Below are comments for four different agenda items of the 1-30-2024 Transportation Commission meeting.

81632 Endorsing / prioritizing bike/ped connectivity as part of WisDOT's I-39/90/94 study

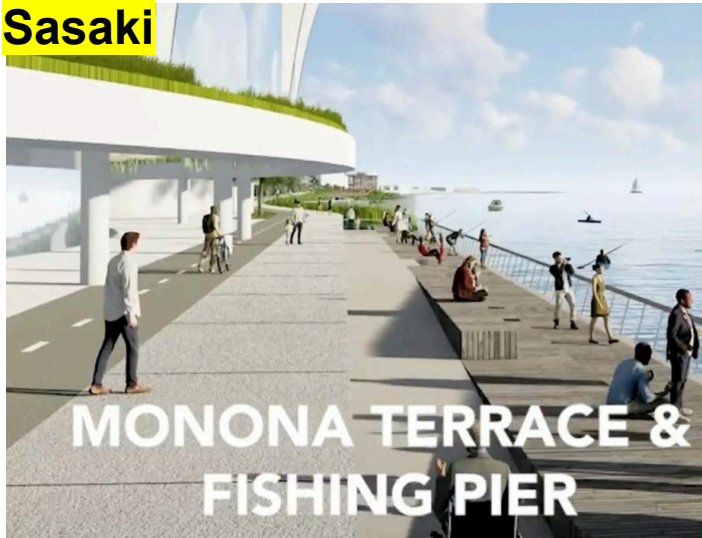
If WisDOT moves ahead with a new Hoepker Rd interchange ([WisDOT, April 2023](#)), the priorities of the pedestrian/bicycle connections at Hayes Rd (currently #5), Hoepker (currently #7), and Anderson (currently #6) should be moved up. This is because a new Hoepker interchange will overwhelm Portage Rd, which is the only bike-friendly Interstate crossing for 6.5 miles.

HIGH INJURY NETWORK

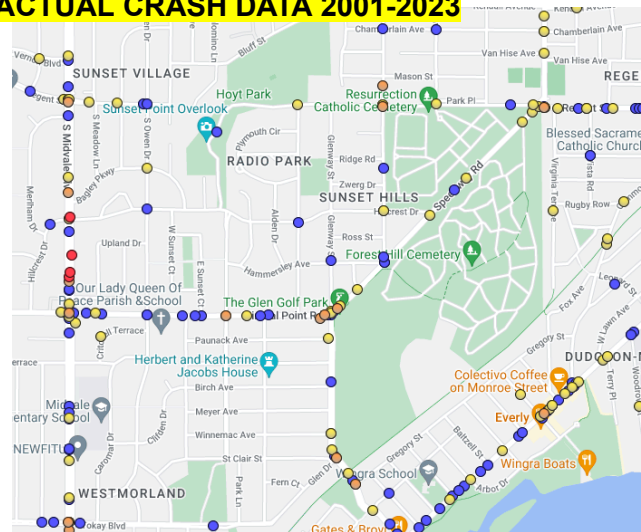
First, High Injury Network methodology used for Vision Zero doesn't seem close to actual injury crash data. E.g., Here is a spot comparison of near-west Madison.

Mineral Point Rd, Glenway, Monroe St, and Regent east of West High all have many real-world crashes with injuries, yet they are not flagged as part of the High Injury Network. The [2014 Near Westside Neighborhoods and University Avenue Corridor Transportation Study](#) (p. 45) indicated that the Glenway / Speedway intersection was the crashiest intersection on the near west side. Meanwhile, streets like Falles Ct are flagged for the High Injury Network even though it's never had a crash and probably doesn't see more than 10 cars an hour.
